Re: Application to Revise Large Mining Operation Permit, Holnam, Inc. Devil's Slide Mine, M/029/001, Morgan County Utah

**RE: DOGM Questions and Review of Application to Revise Large Mining Operations/Permit
Overburden Dump, Devil's Slide Mine, M/029/001
Devil's Slide Plant - Morgan County, Utah**

Devils Slide Plant Overburden Dump Profile A

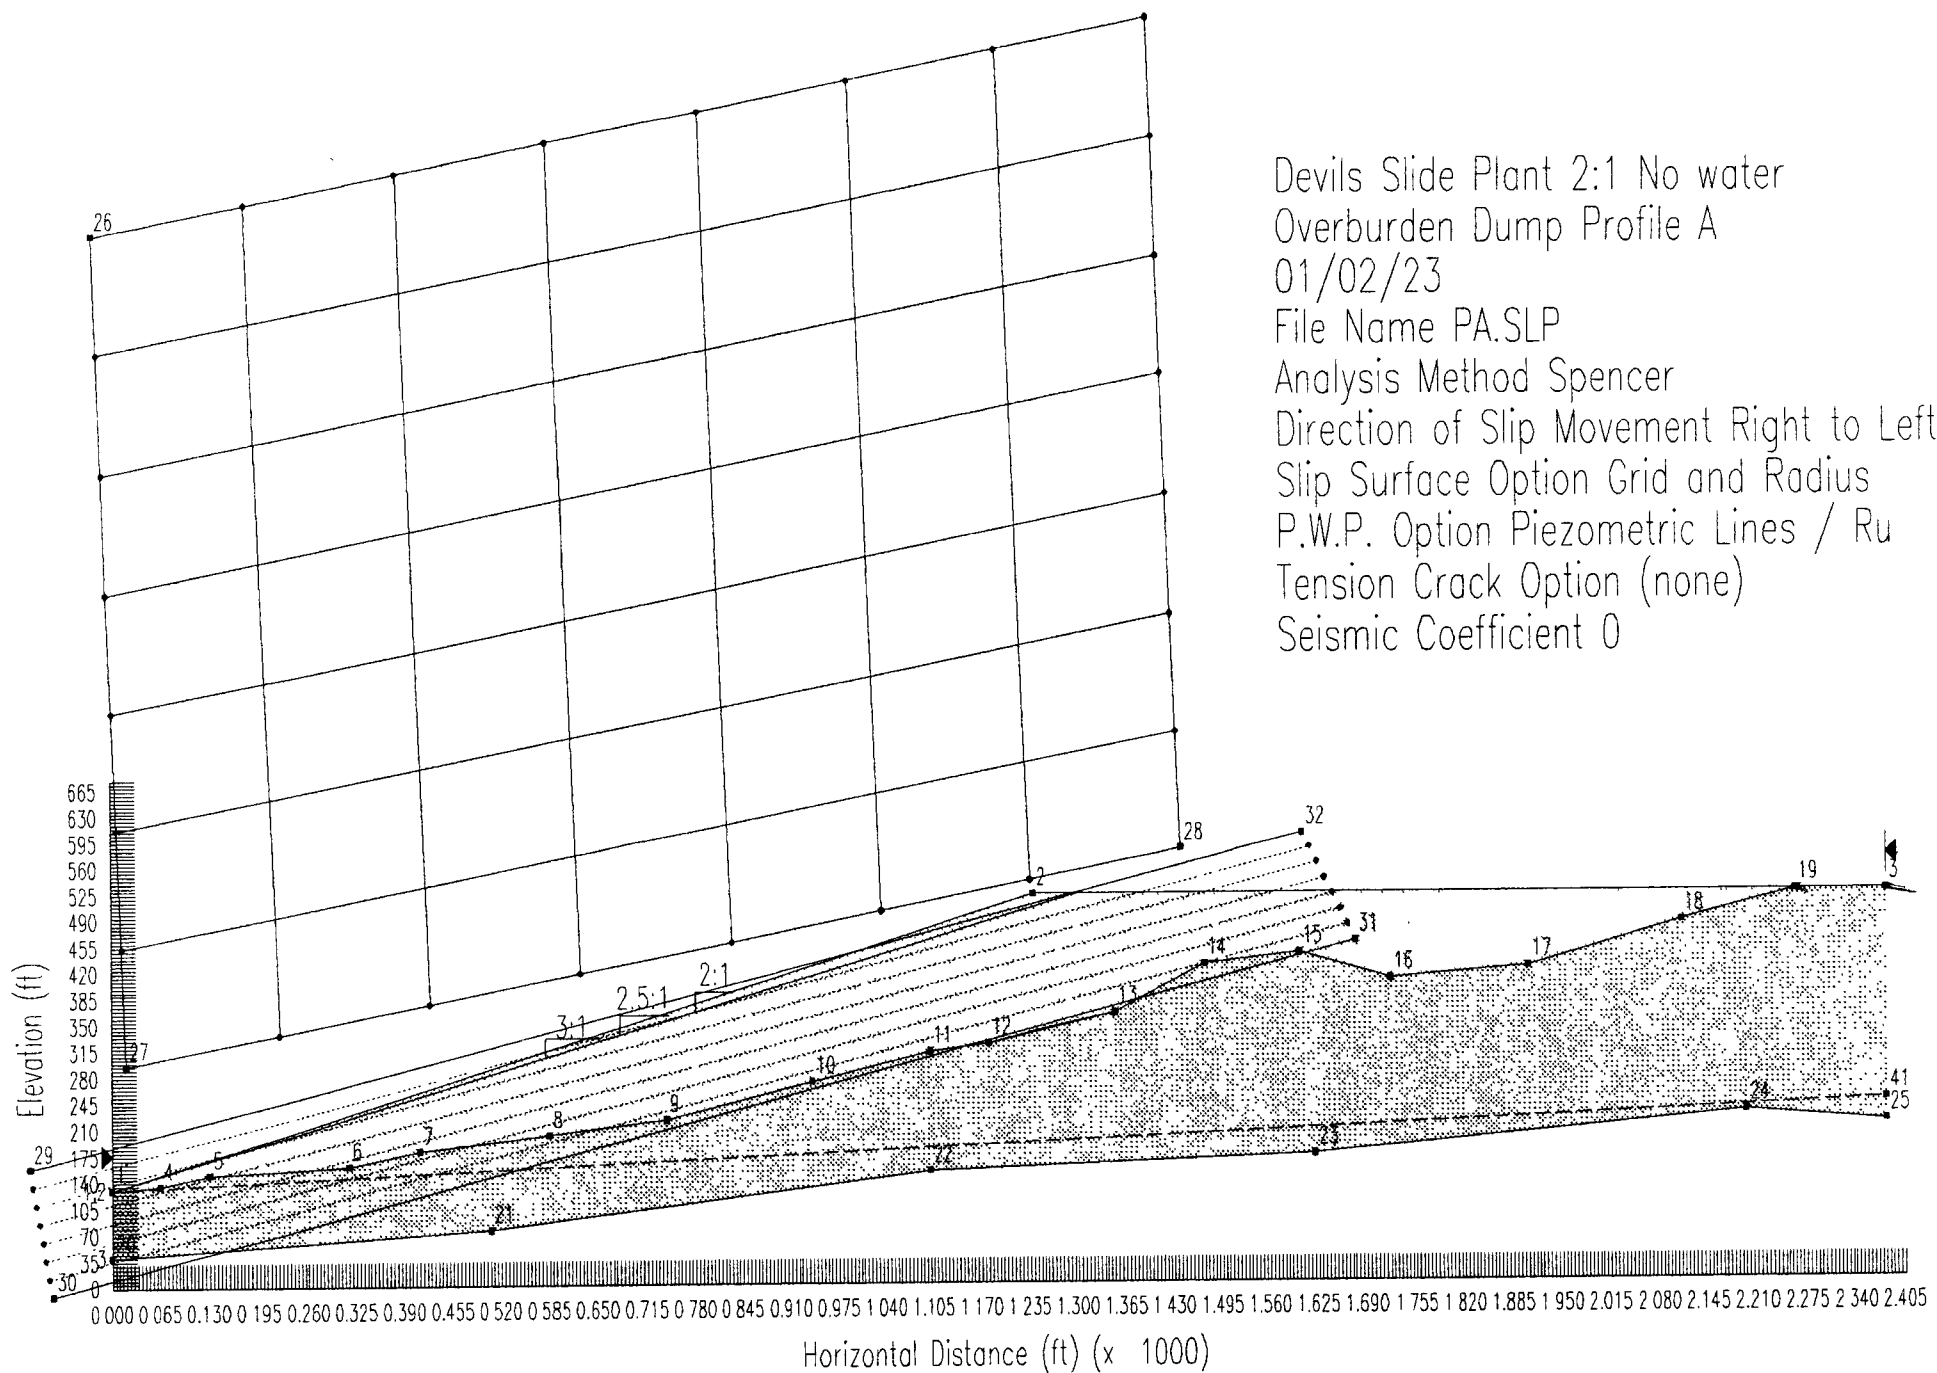
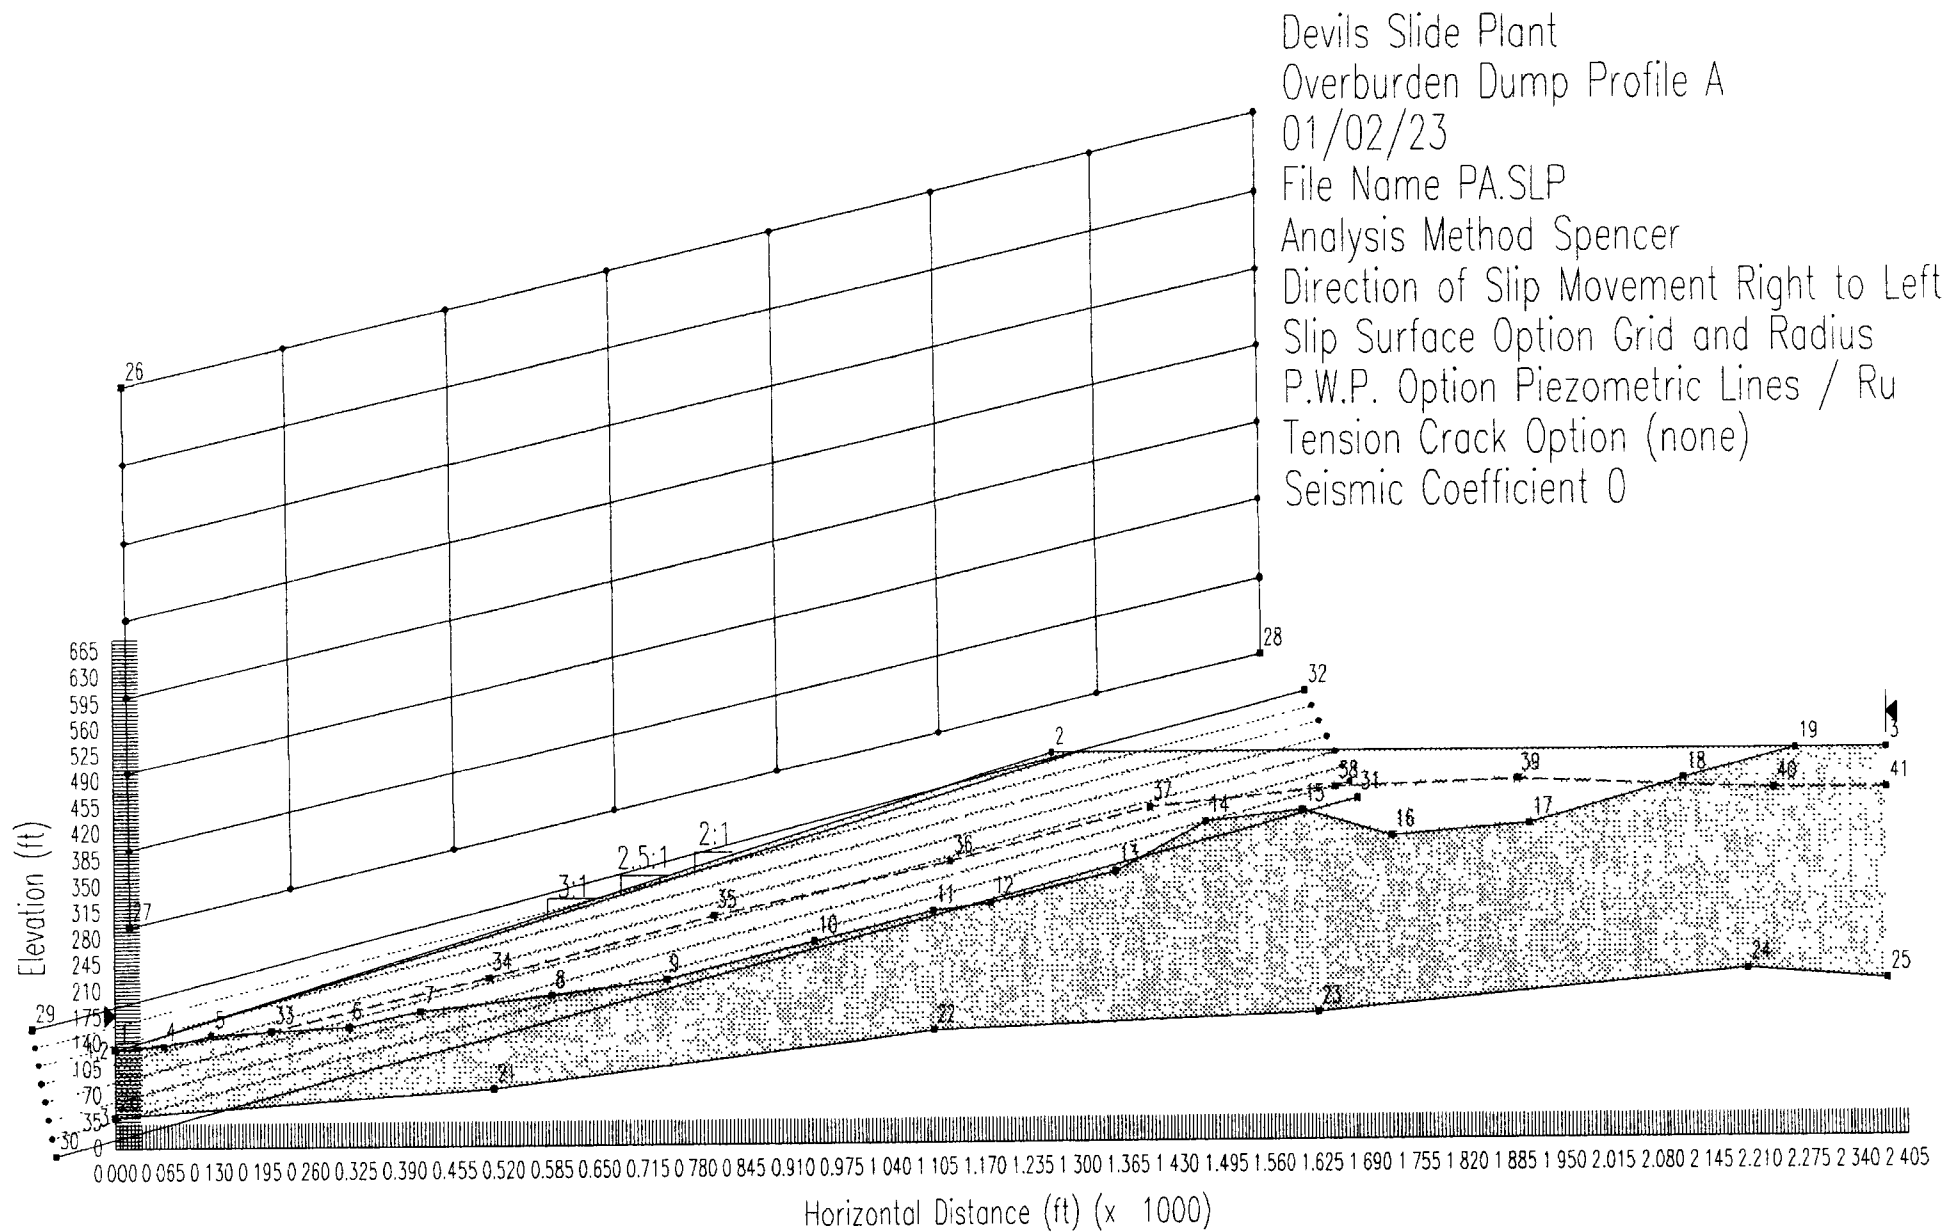
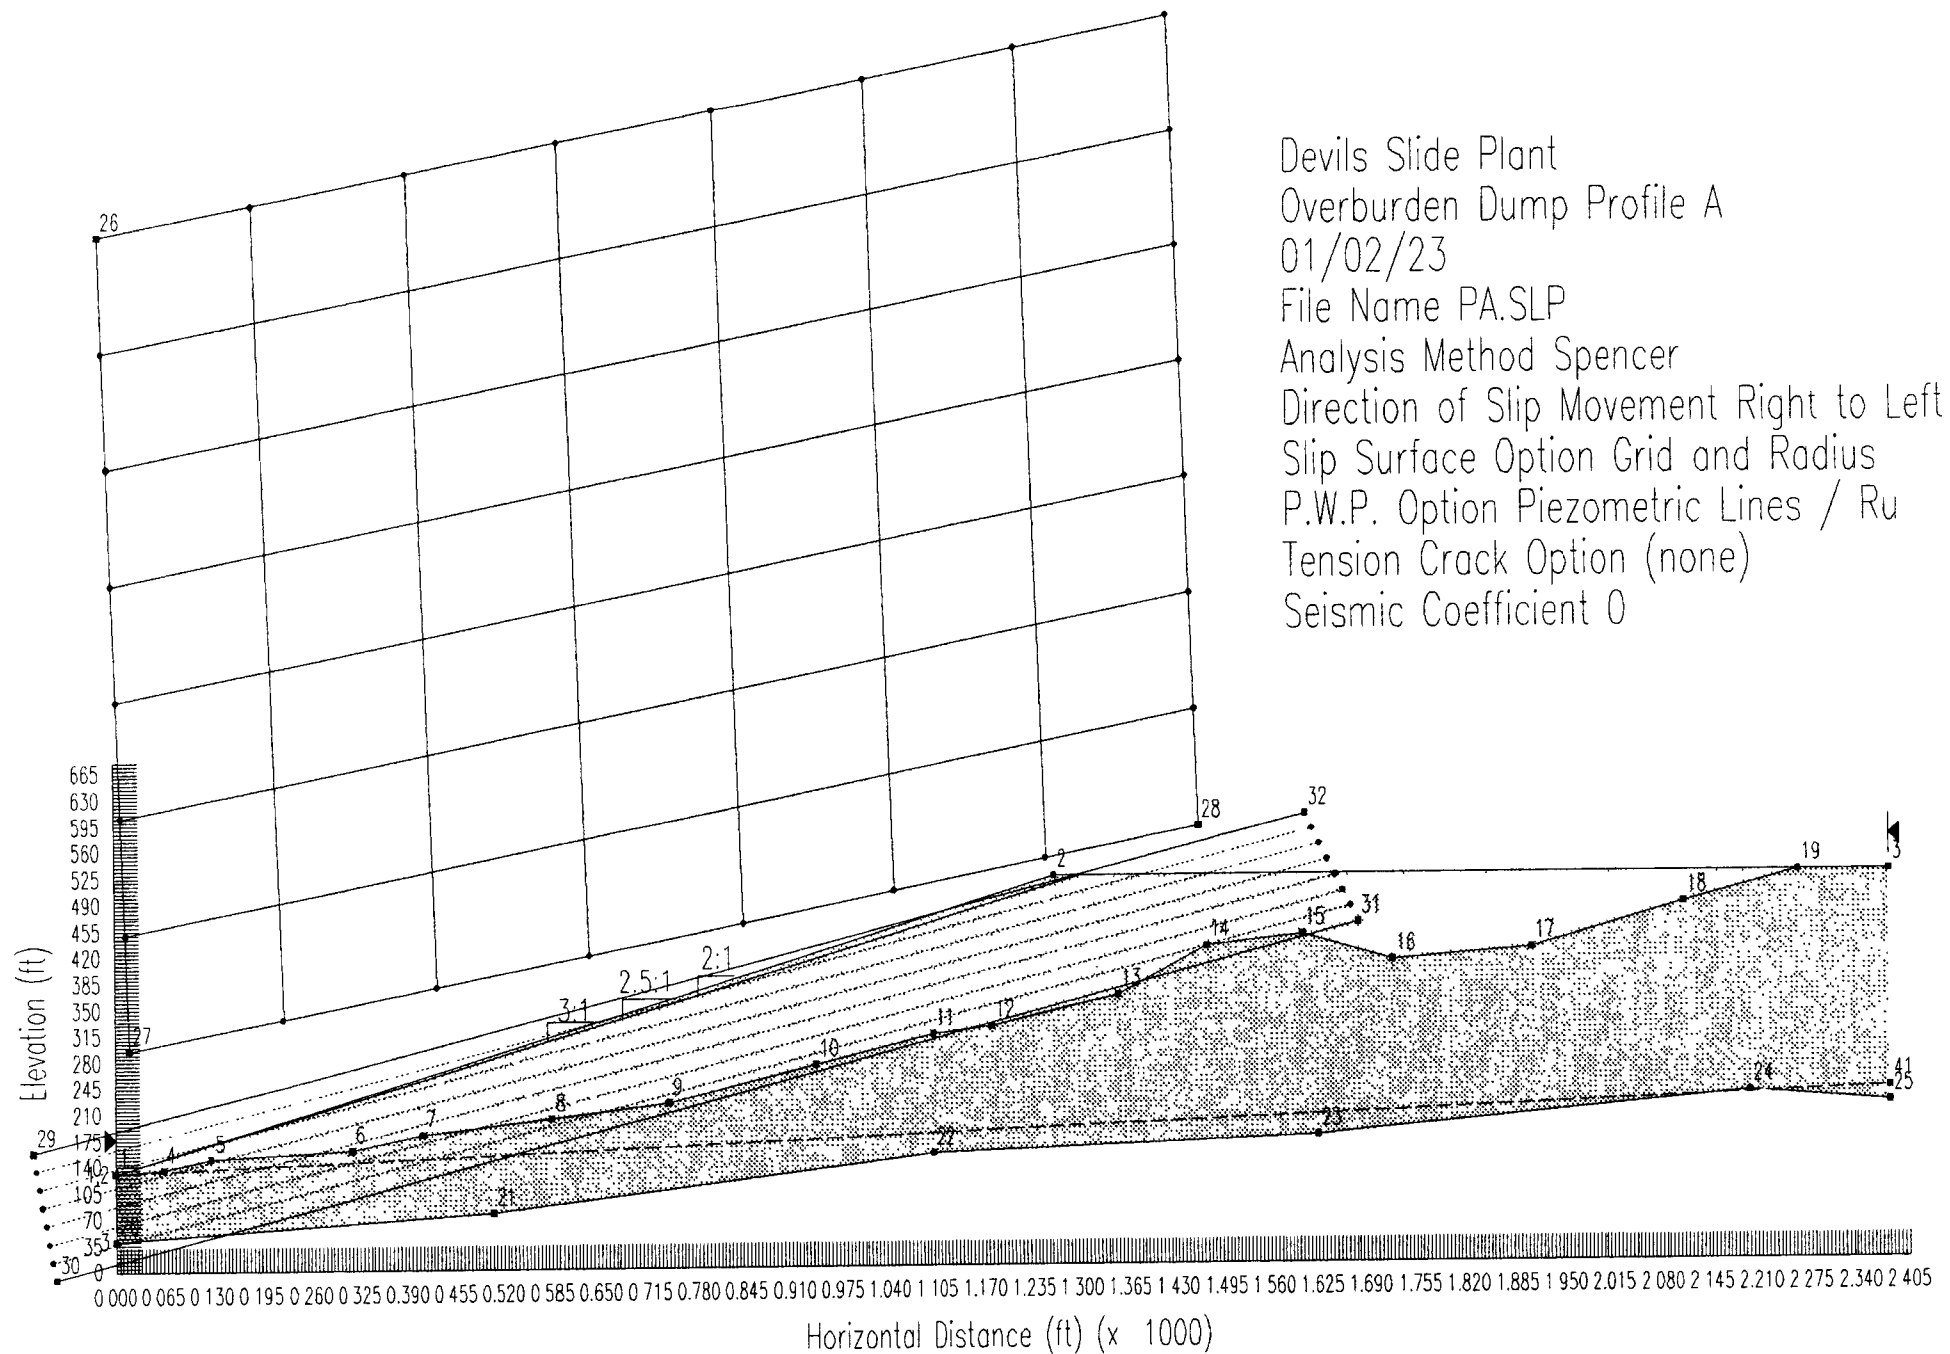
DOGM: *The submission states that slopes will be spread and contoured is ambiguous. Please clarify this statement by describing which slopes will be affected and how they will be contoured along with slope angles, etc., needed to complete this task.*

Response: A slope stability analysis was conducted for the proposed Overburden Dump. For this analysis, Holnam reviewed three possible "re-contoured" slope gradients under high and low

groundwater conditions. The three slope gradients examined include a 2:1, 2.5:1, and 3:1 Horizontal to Vertical (H:V) slopes. The slope stability evaluation examines the slopes under static loading conditions using a "grid & radius" failure search program, which defines a rotational slump failure. Soil strength information (internal friction angle, cohesion and unit density) has not been developed for this site through drilling and material testing. Subsequently Holnam is using historical data from material testing of the limestone at the Devil's Slide mine in addition to published literature regarding soil & rock strength based on similar soil types. Published references have been submitted for review in subsequent paragraphs under this question. In the following Holnam's approach to calculating the slope stability analysis is presented.

The slope stability analyses were performed on profiles A-A', and B-B' (see Map DCC-1702 - Holnam Cross Sections of the Overburden Dump, Scale under the figures section). Profile A-A' is located down the center of Quarry Hollow, which includes some of the deepest portions of overburden dump. The second profile, B-B' is located through the steepest portion of the Overburden Dump that extends to the west into Cottonwood Canyon. Both profiles encompass the total length and depth of the proposed overburden dump. The Overburden Dump slope stability analysis was completed by utilizing the SLOPE/W Version 3 (1995) computer program GEO-SLOPE© International Ltd., Calgary, Alberta, Canada, to compute factors of safety against failure. The factor of safety is the ratio of the forces resisting the slope movement to the forces, which cause the slope to fail. The resisting forces are determined by the shear strength of the overburden dump soils to resist failure along a specific surface. The forces which tend to cause failure include, but are not limited to: (a) the angle of the slope; (b) the location of existing roads and drainage ditches in relation to the slope; (c) pore pressure or water table acting on the failure plane; and (d) the characteristics of the soil placed in the overburden dump. A factor of safety of 1.0 implies that the slope is marginally stable for cross-section profiles, overburden soil material strengths, groundwater, and slope gradient conditions. Surface water was not evident during the calendar year 2000 field investigation, except in a shallow depression used for watering cattle.

Profile	Slope Gradient (H:V)	Perched Groundwater Table	No Groundwater Table
A-A'	2:1	1.41	2.04
	2.5:1	1.42	2.08
	3:1	1.42	2.13
B-B'	2:1	1.39	1.96
	2.5:1	1.40	1.98
	3:1	1.99	1.99

DETAILED DRAWING
RUNOFF INTERCEPTION DITCH
R647-4-107-OPERATING PRACTICES

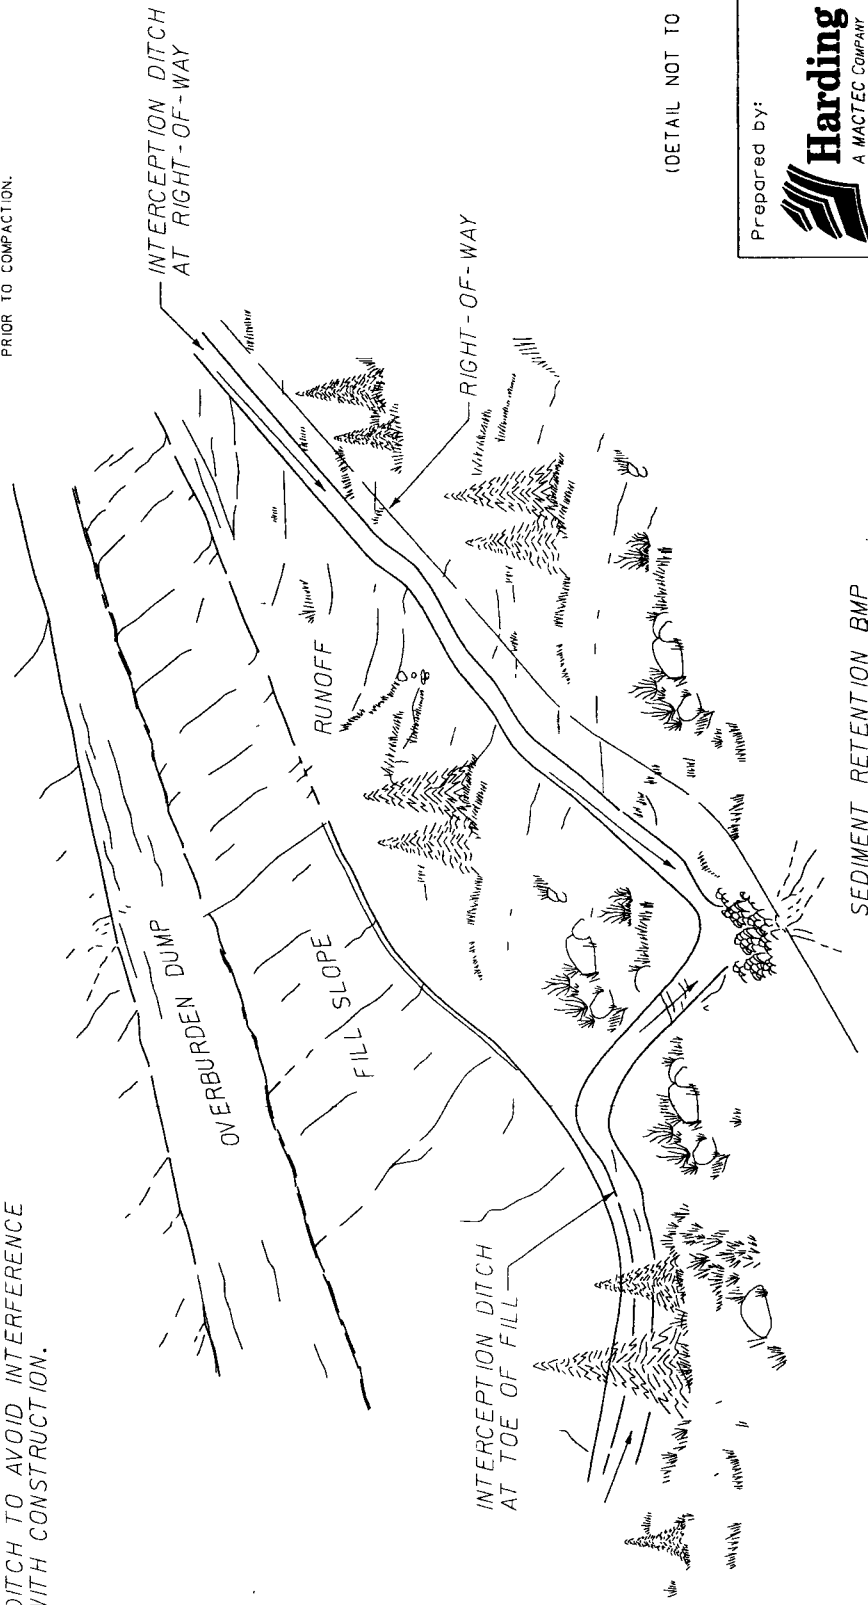
DOGM: *It is important to provide a demonstration of onsite erosional stability through the application of current practices of surface roughness, slope breaks, etc. Please provide this demonstration.*

Response: Published and unpublished standards for slope/surface roughness erosion control have been reviewed. A detailed drawing with supporting text for slope roughing of the Overburden Slopes has been provided (Appendix B). Overall stability of the Overburden Dump is discussed in Section 106.2, Slopes breaks and erosional stability addressed in Appendix A of this letter.
